TEAC TECHNICAL INFORMATION

TASCAM MMC-38, Change of the Software

TASCAM DA-38/88/98, Impedance Roller Height Adjustment

TASCAM DA-38/88/98, Changes on Mechanism (S-Err 08/31)

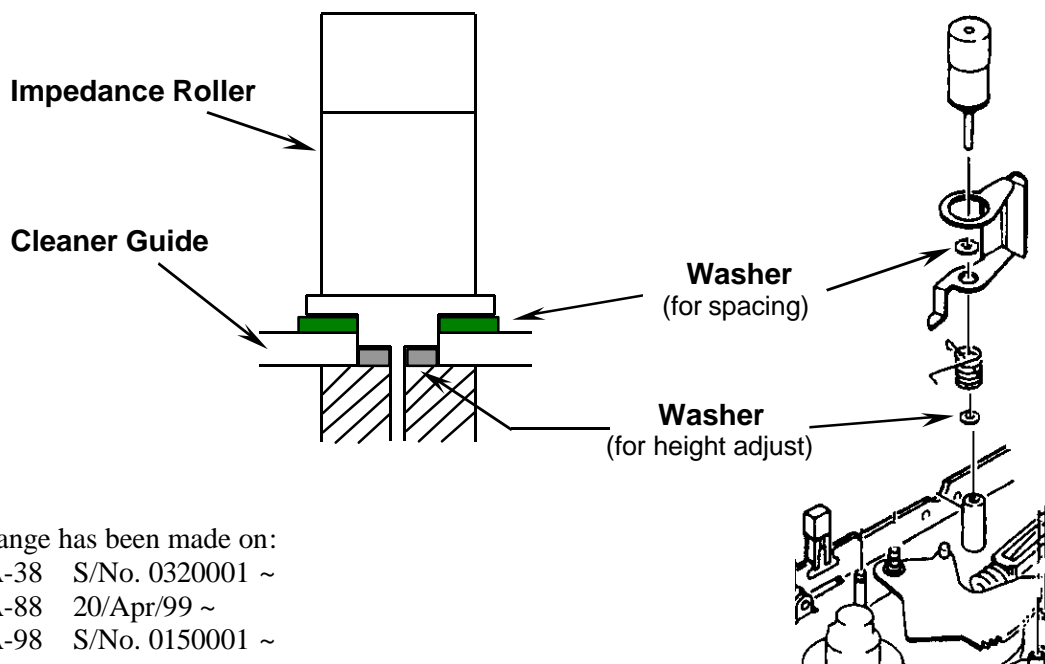
A washer (Procedure 4-6-1, DA-38/98 service manual) has been used to adjust the height of impedance roller. If thicker one is used, there is a possibility that a lever of cleaner guide and a pin of sector gear do not engage causing incomplete tape loading.

To fix the height of cleaner guide uniformly, three pairs of washer have been newly used.

Pair 1	Pair 2	Pair 3
Washer (for spacing)	M0090660 (3.85×6×t0.2)	M0090670 (3.85×6×t0.25)	M0090680 (3.85×6×t0.3)
Washer (for height adjust)	M0090610 (1.63×3×t0.13)	M0090620 (1.63×3×t0.2)	M0090630 (1.63×3×t0.25)

Notice: Do not mix different pairs.

Shield Cover, P

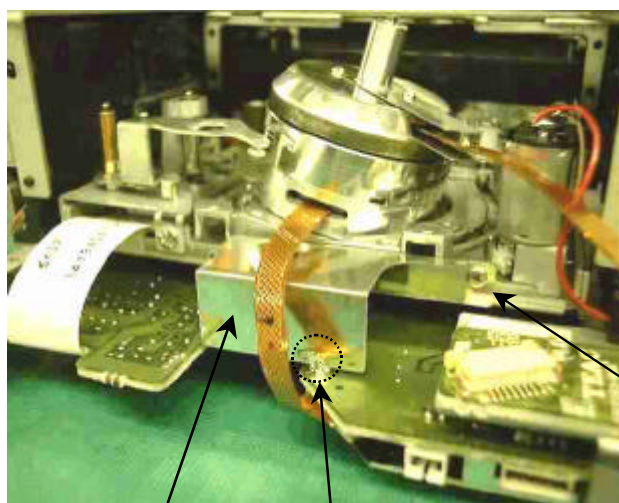
In case (-00B) head is mounted on the DA-38 S/No. up to 0139999, error rate may deteriorate as shown below.

Solution is fitting a shield cover that has been applied on the products S/No. 0140001 and higher.

Solder here.

Apply M2x4 screw here.

TASCAM DA-38 / DA-98, S-Error 02

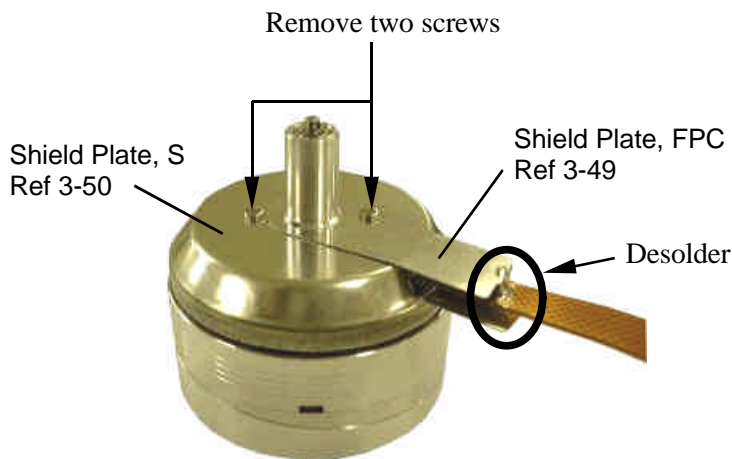
Symptom: Drum hesitates to rotate smoothly. [S-Err 02] is displayed.

Cause: Recording Rotary Transformer gets stuck. Gluing was not proper on some Rec Rotary Trans.

Solution: Replace the rotary transformer with Rec Trans Assy (SV), P/No. V000863-00A.

1 Disassembling

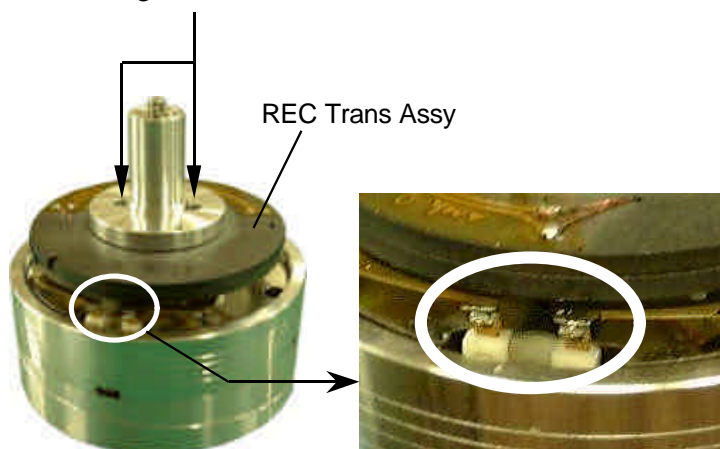
Rotate the REC Trans Assy so that two screws can be found through the holes. Remove those two screws.

Desolder the head terminals.
 (There are same terminals at the opposite side.)

SYSTEM CONTROL PCB (1/2)

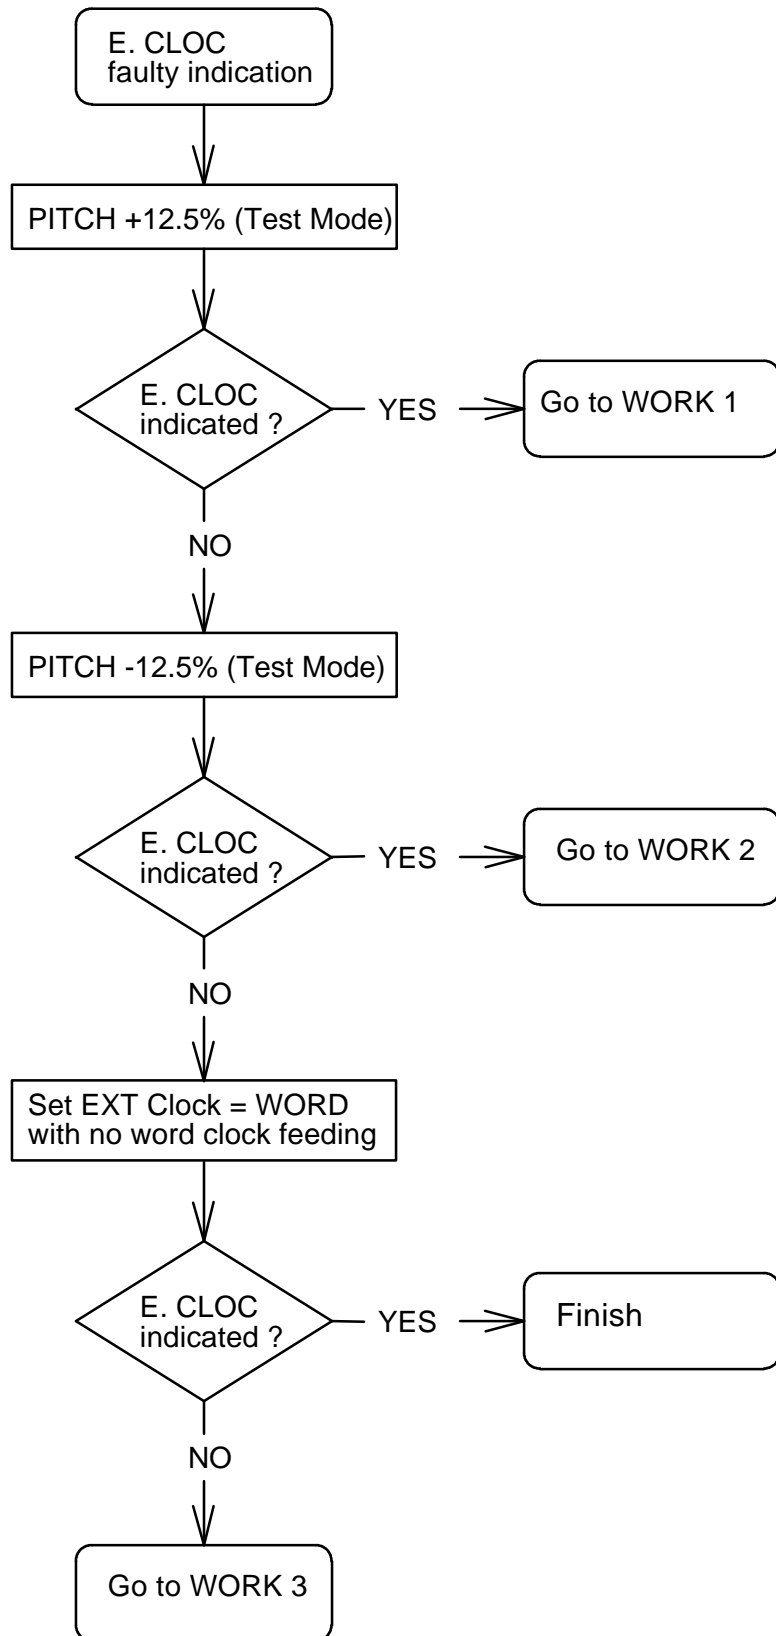
Replace C41 (15 pF) with 12 pF then point ① becomes 4.5 V or less.

Replace C54 (27 pF) with 22 pF then point ② becomes 4.5 V or less.

Replace R162 (180 Ω) with 180 Ω ~ 10 kΩ then point ① becomes 1 V or more.

Replace R163 (180 Ω) with 180 Ω ~ 10 kΩ then point ② becomes 1 V or more.

Replace R162 (180 Ω) with 180 Ω ~ 0 Ω then point ① becomes 1 V or less. If problem still exists, connect resistor 10 kΩ ~ 100 kΩ parallel to R25.

Replace R163 (180 Ω) with 180 Ω ~ 0 Ω then point ② becomes 1 V or less. If problem still exists, connect resistor 10 kΩ ~ 100 kΩ parallel to R30.

Old	New
R25/R30	4.3 kΩ	3.9kΩ
R162/R163	jumper wire	180 Ω

TEAC**TECHNICAL INFORMATION****TASCAM DA-88, WORD IN from Emitter Follower Driver**No. **9838**

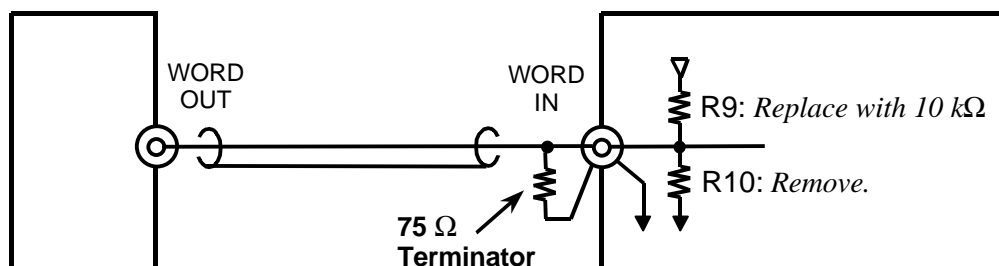
If the word clock is fed to the DA-88 from machines that use emitter follower type drivers at the word output stage, the DA-88 will not synchronize to the word clock.

- 1) Replace R9 on the SYS PCB Assy with 10 k Ω , 1/4 W, **P/No. 52400306-20**
- 2) Remove R10.
- 3) Connect an outside 75 Ω termination via a BNC T-piece.

Overview of WORK 1, 2 and 3

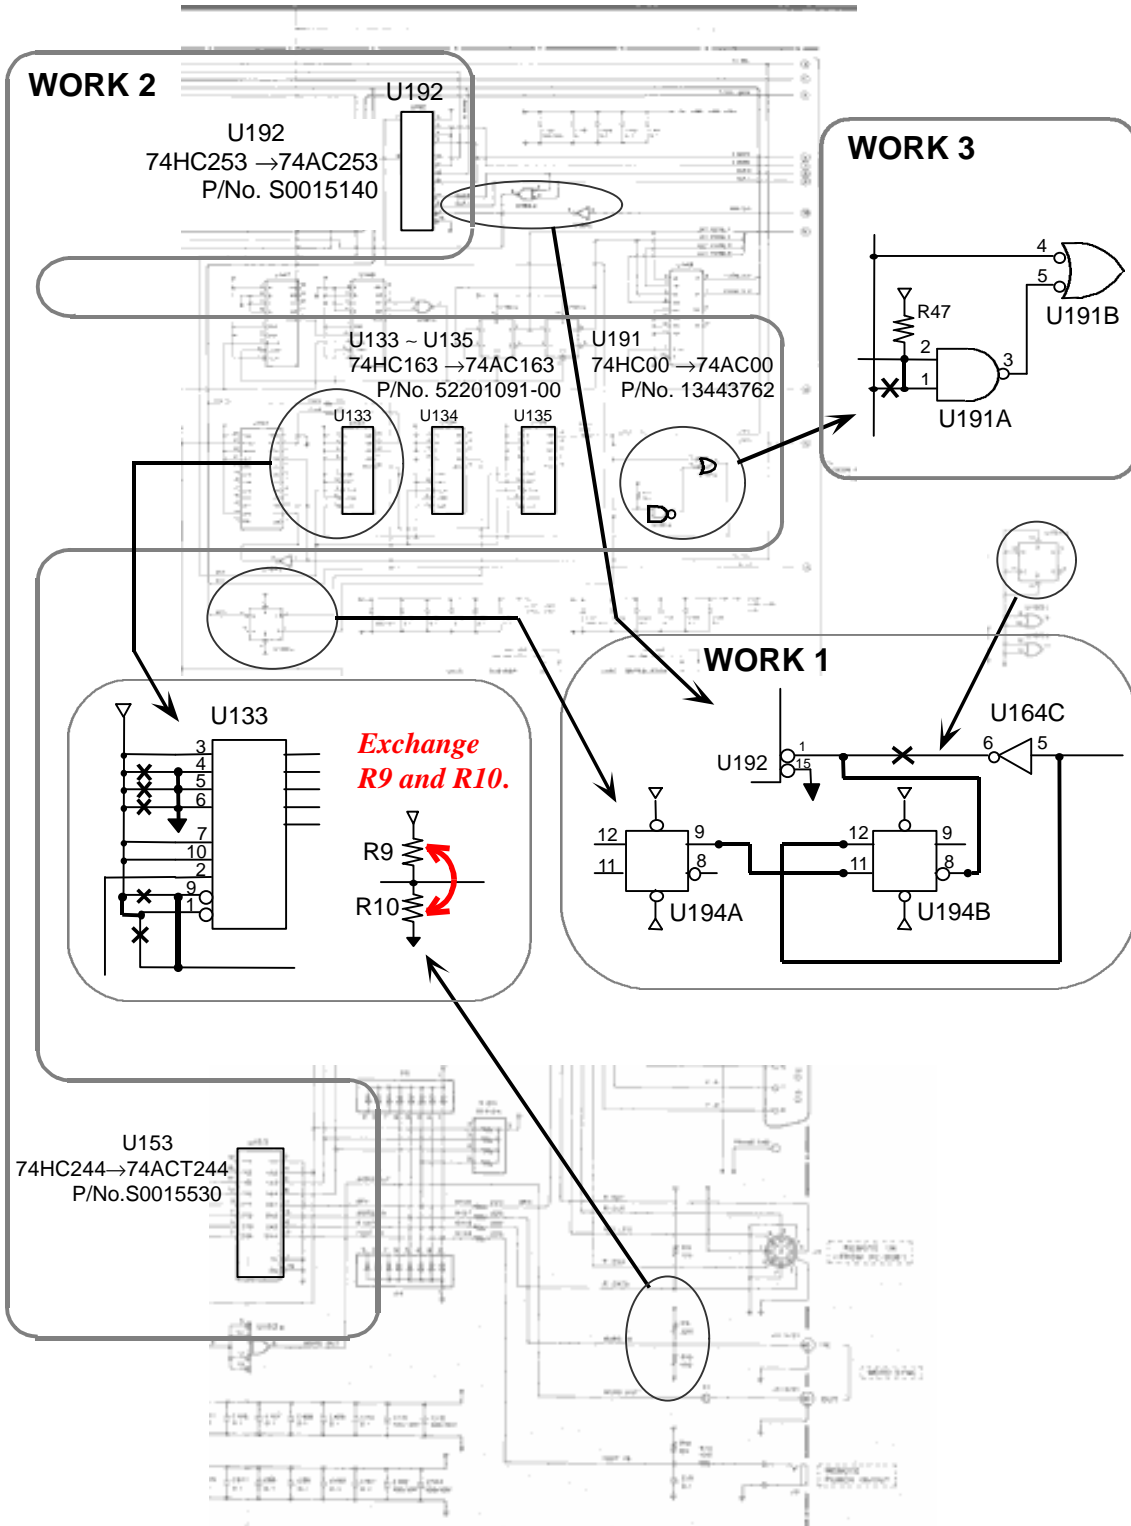
- 1) One sample delay. Odd and even channel signal outputs are inverted.
- 2) Digital dubbing from slave to master is impossible or gets noise with using PW-88DL cable.
- 3) Noise on record or play.

Refer to page 3 and 4 for more details.

Circuit Diagram

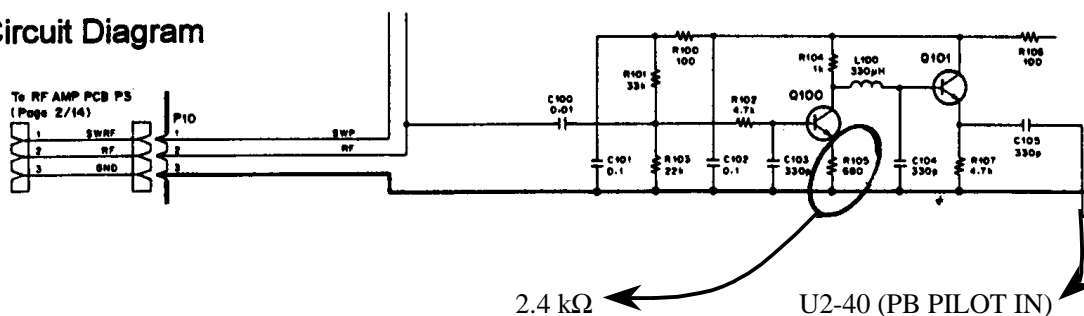
Cause: The ATF signal is recorded with too much level for certain tape formulations..

U2-43 (PRE AMP OUT)
ATF signal too much level

This change has already been made on units with S/No. 450001 and higher.

Fig.1

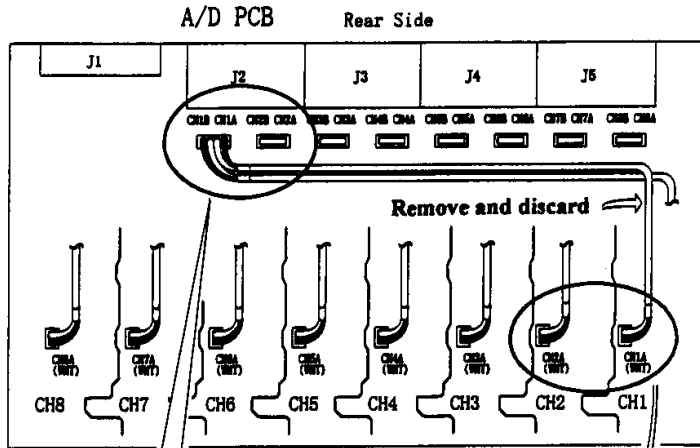
- ① Cut wire of CH1A and CH2A connectors and remove and discard it as shown in Fig.1.
- ② Attach the Buffer Amp PCB Assy by the adhesive tape as shown in Fig.2.
- ③ Remove * marked four components per Buffer Amp PCB as shown in Fig.3:

Fig.3

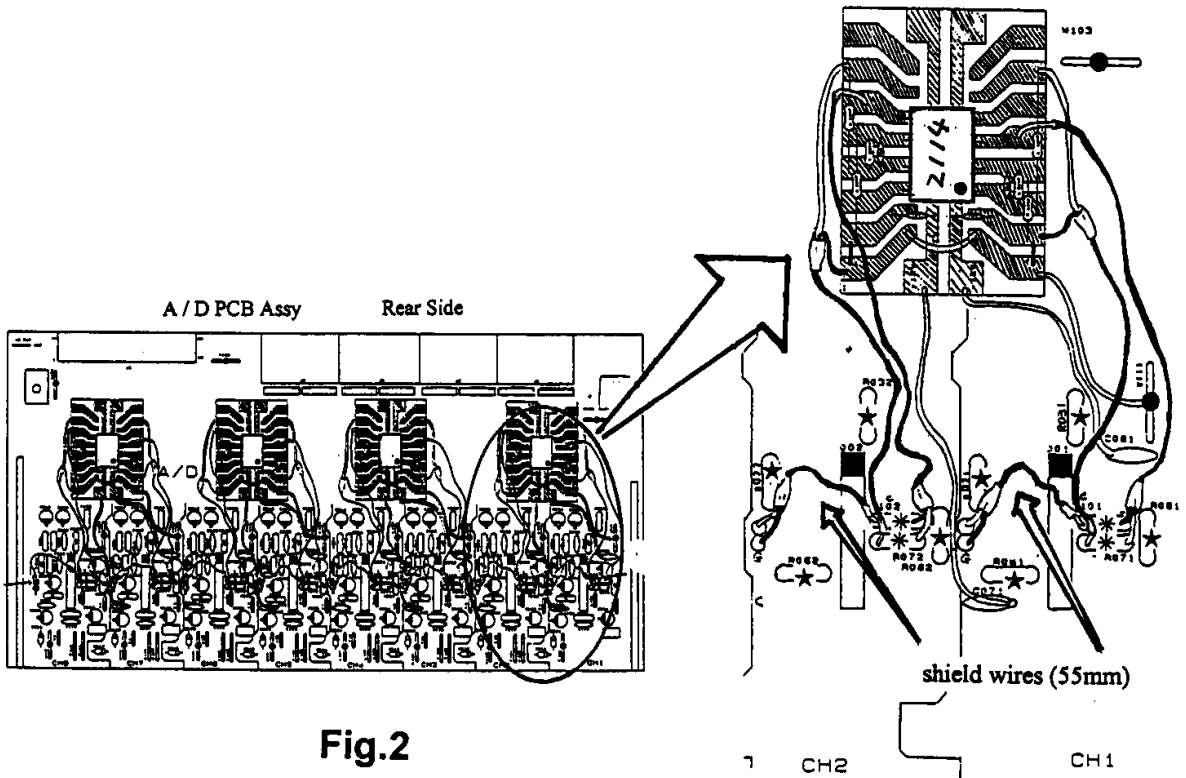
- ④ Replace * marked eight resistors with the supplied resistors per each Buffer Amp PCB as shown in Fig.3:

C103 ~ 108 (680 p)	→	Remove (*)
R073 ~ 078 (220)	→	Remove (*)
R023 ~ 028 (1.3 k)	→	1.8 k (*)
R033 ~ 038(220)	→	1.8 k (*)
R063 ~ 068 (220)	→	4.7 k (*)
R083 ~ 088(56 k)	→	10 k (*)

Fig 2

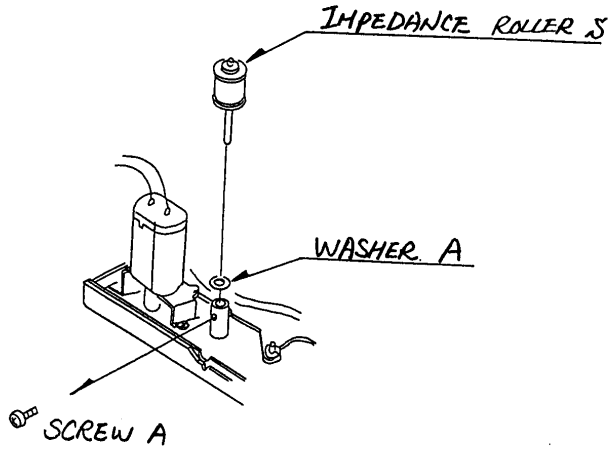
- 1.3 Remove Screw A. This screw is used again, do not lose it. See Fig 2.
Remove existing Impedance Roller S Assy and polyester Washer A. Abandon them. See Fig 2.

Fig 6

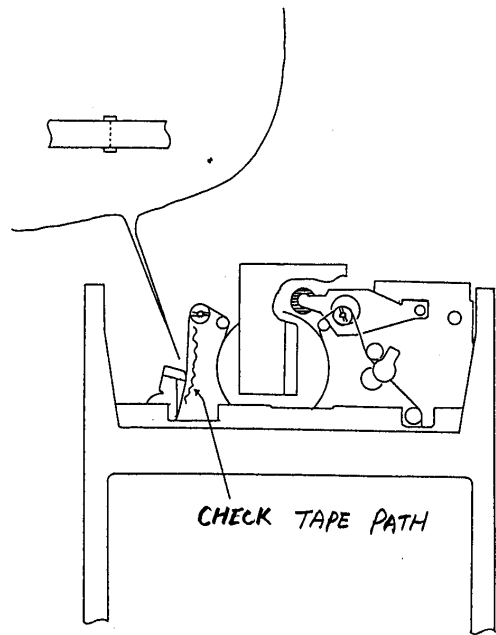
- * While tape runs, no curl of tape occurs on the lower portion of Impedance Roller S. See Fig 6.
- * Tape touches even on the blade of cleaner guide. See Fig 6.
- * Adjust VC0 Offset again. See 3-4 at page 13 S/M.
- * Ensure that the error rate is within specification, and also within the value measured in advance of performing modification. See 3-7-3 at page 17 S/M.
- * Ensure that RF wave form is within the value specified. See 3-5-3 at page 15 S/M.

Fig 7

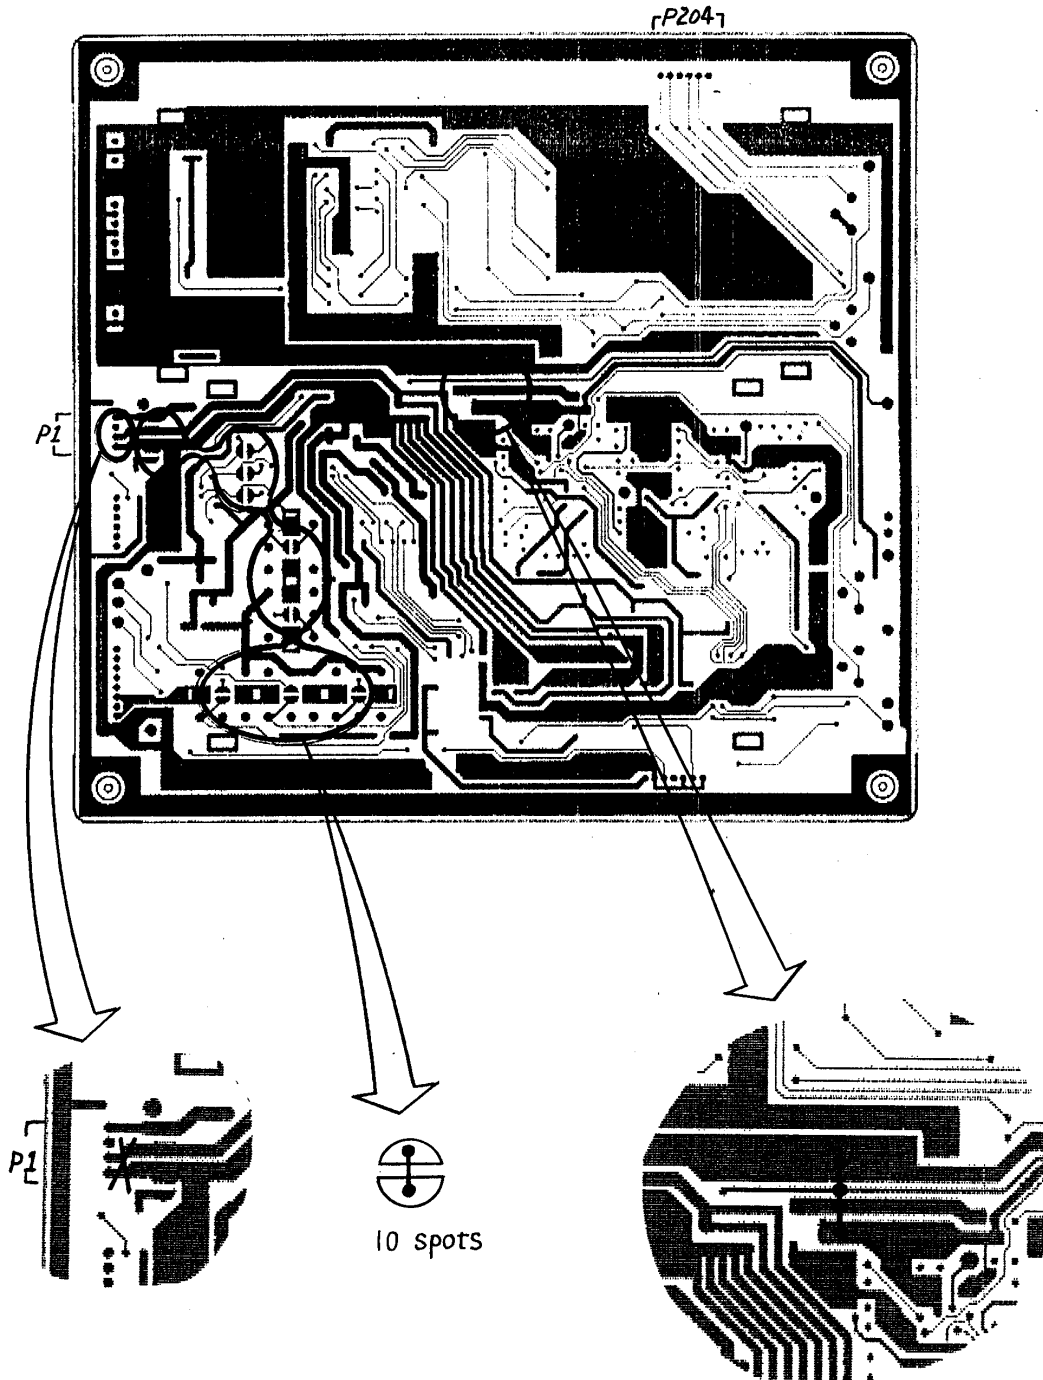
- 1.0 Modification on Foil Pattern Side.
Dismount REC/PLAY PCB Assy from main unit. See Fig 1.
Assume that the PCB Assy stands upright with its P204 connector atop, foil pattern side facing operator. See Fig 7.
Perform following modifications.

Spots on Servo PCB Assy

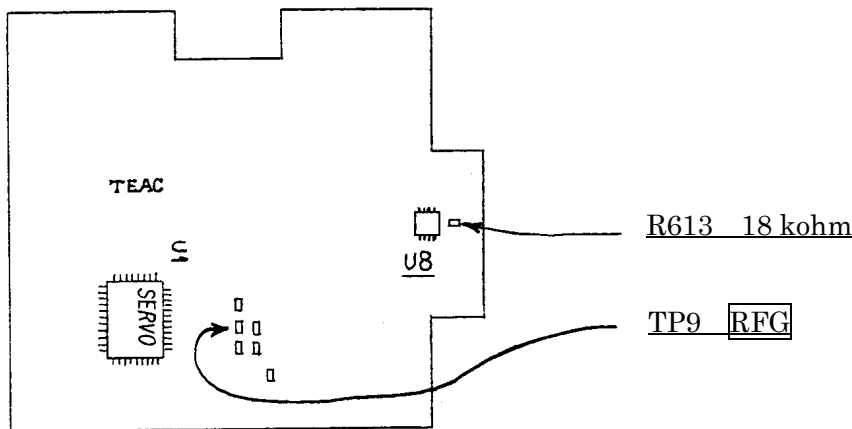
1-5 To replace R613 resistor, remove whole PCB Assy because the resistor is located under metal plate.

In case the R613 is found replaced with 20 kohm already, replace it again with 22 kohm, and proceed to 1-1 through 1-6 steps.

In case the R613 is found replaced with 22 kohm already, replace IC U8, change the 22 kohm to 18 kohm.
